Council Reference: A006894653
Attention: Shirley Mills

RE: Response to Information Request – Development Application for a Reconfiguring of a Lot (1 into 2) at 104 Idonia Street, Bridgeman Downs

Figure 1: Proposed Plan of Subdivision (Source: Lawson Surveys)

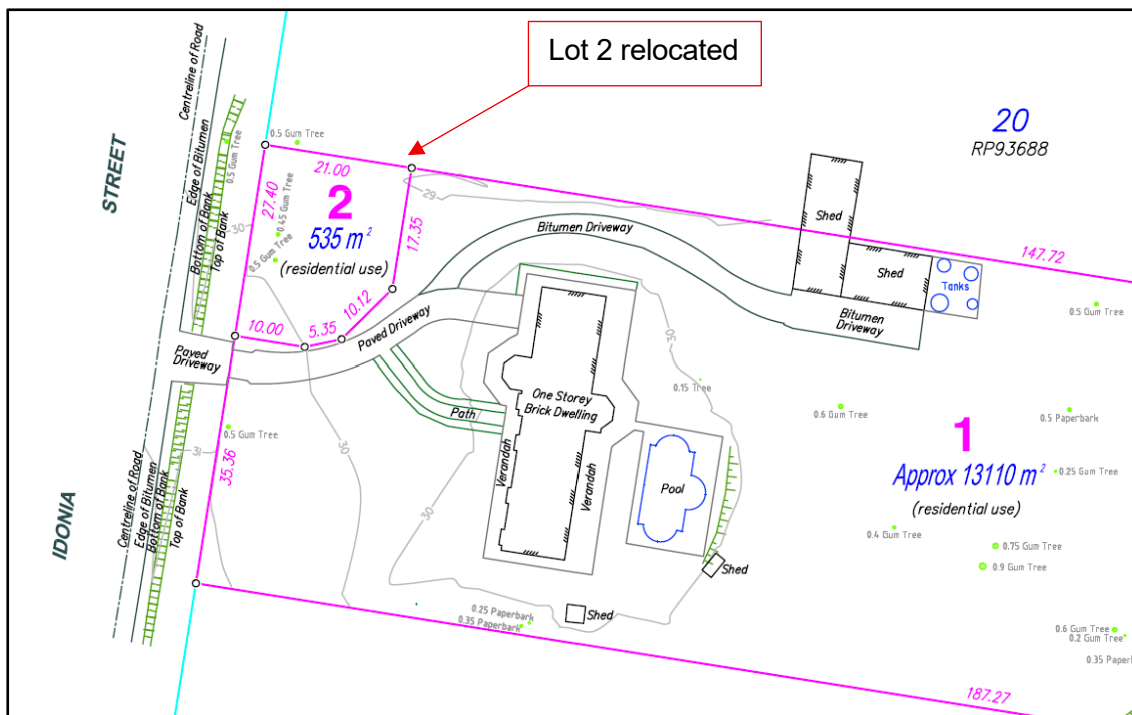
a) Provide amended plans that relocates the proposed new lot to the north-western corner of the site and demonstrates ecological connectivity and restoration of an east-west ecological corridor that encompasses the area designated as the Environmental Protection Zone, as shown in Figure 1.

Following ongoing discussions with Council, the Plan of Subdivision has been amended to relocate Lot 2 along the northern boundary (Figure 1).

Lot 2 proposes a total area of 535m² and a frontage to Idonia Street of 27.4m, which can accommodate a minimum 300m² development pad.
